TECHNICAL BULLETIN

Plenum Chamber Drain Valve –
Distorted – Water Entering ECM –
Service Action S619

MODEL 1995 MY
Sedan (4.0L) Range
VIN 720001-725767

ILLUSTRATION 1

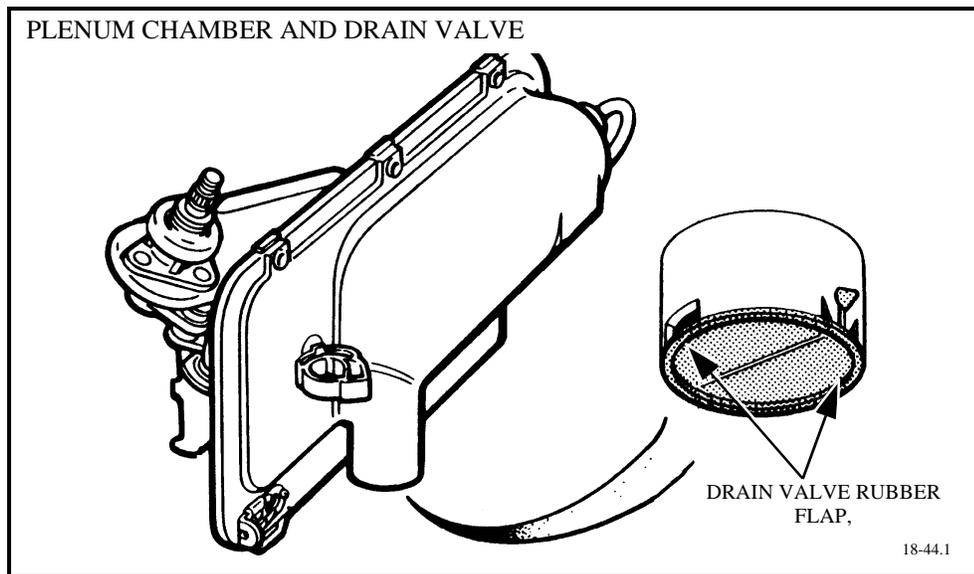
The plenum chamber water drain valve rubber flap may be incorrectly installed in some 1995 MY Sedan Range vehicles from VIN 720001 to 725767. In some cases the rubber flap may restrict the water drain tube causing water to leak down the “A” posts. The leaking water may damage the ECM.

At the next service opportunity, or during PDI, check the plenum chamber drain valve rubber flap (Illustration 1) of all 1995 MY Sedan Range vehicles within the VIN range. Follow the procedure described below.

1. Visually inspect the drain valve rubber flap using a light and mirror.
 - If the drain valve rubber flap is in the correct position, as shown in Illustration 1 above, no further action is required.

ILLUSTRATION 2

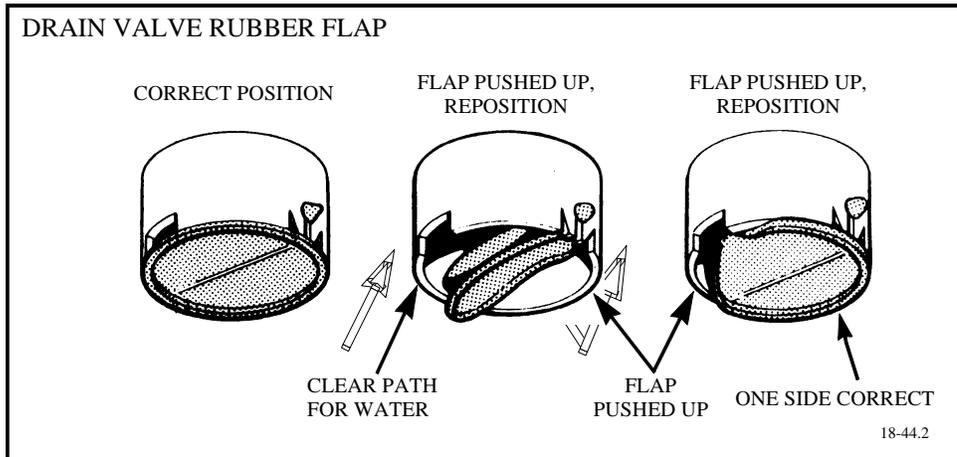
2. If the rubber flap is pushed up, with one side open to allow a clear path for water drain (Illustration 2) or with one side in the correct position, reposition the flap to the correct position with the fingers. No further action is required.

NOTE: The rubber flap must be free from the drain tube walls to allow water to drain.

ILLUSTRATION 3

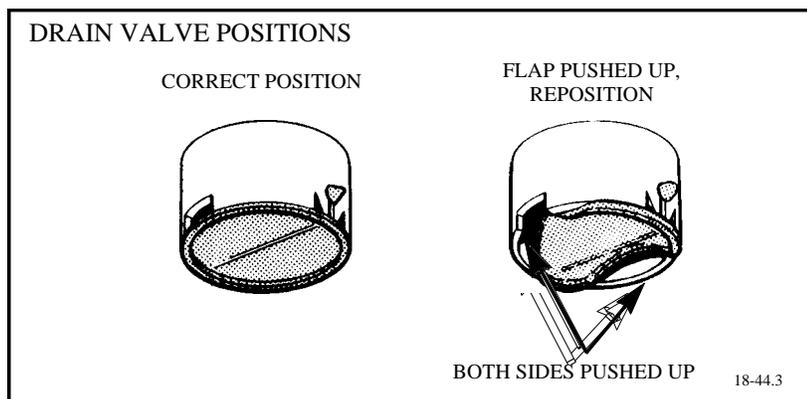
3. If the rubber flap is pushed up into the drain tube, with both sides restricting water flow (Illustration 3), reposition the flap to the correct position with the fingers and check the ECM for signs of water damage.
